Item Name: Replacement Skidtube with Run-on Landing Wearplates, Fits LH or RH

DART AEROSPACE LTD		Work Order:	118478
Description: Repair Scheme D119-646-241 Skid tubes FWD GHW holes do not align NCR 14-3771 For tubes in production and Returned tubes			
Drawing: D3887		Repair Scheme:	RS1015
Part No: D119-646-241		Page:	1 of 1
Batch No:		Qty:	1

DETAIL C
TYPICAL
SCALE 4X
C1-5
C1-6

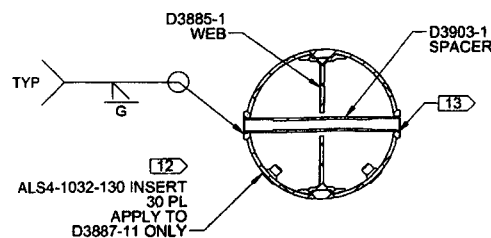
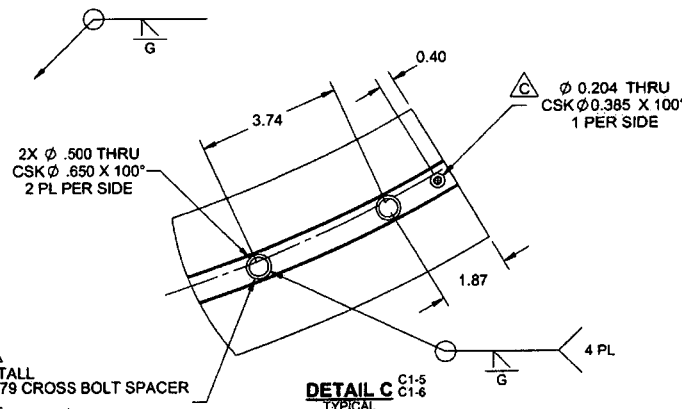
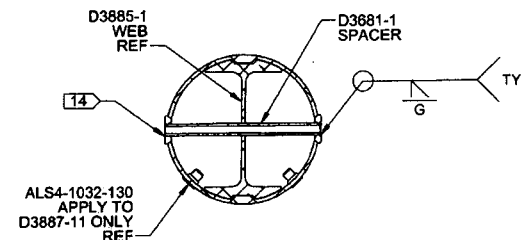
Drill out & remove FWD Cross bolt spacers D2579 in Detail C on Dwg D3887SKI

Reposition location of holes as per Drawing but using +/-0.005" tol and per symmetrical in QSI 018

TACK ONLY CroHss bolt spacers D2579 B 123997 x1

Step	Location	Procedure	By	Date	Qty
1	Finishing	Remove FWD & AFT caps D2855-3. Clean all sikaflex off cap & identify per each tube caps was removed (P/N & B#)	BE	14-10-27	1
2	Skidtube	Drill out & remove FWD Cross bolt spacers D2579 in Detail C on Dwg D3887	BE	14-10-27	1
3	Skidtube	Reposition location of holes as per Drawing but using <u>+/-0.005" tol</u> and per symmetrical in QSI 018	BE	14-10-27	1
4	Skidtube	TACK ONLY Cross bolt spacers D2579 B <u>123997</u> x1	BE	14-10-27	1
5	QC	Location MUST be verified by QC Record Dims HERE insp. with sig DT10091	PD	14-10-27	1
6	Skidtube	Weld as per QSI 004 A/R <u>M129285</u> Back Drill Grind welds flush & deburr	BE	14-10-27	1
7	QC	QC 10 & 5 Inspection ***TEST FIT/GHW WHEELS*** <u>Pass</u> ☒ with sig DT10091	PD	14-10-27	1
8	Purchasing	Send tube to be striped as per QSI004 PO# <u>26625</u>	CZ	14-11-26	1
9	Receiving	Receive & Inspect for Damage & Material certs	IK	14-12-8	8P
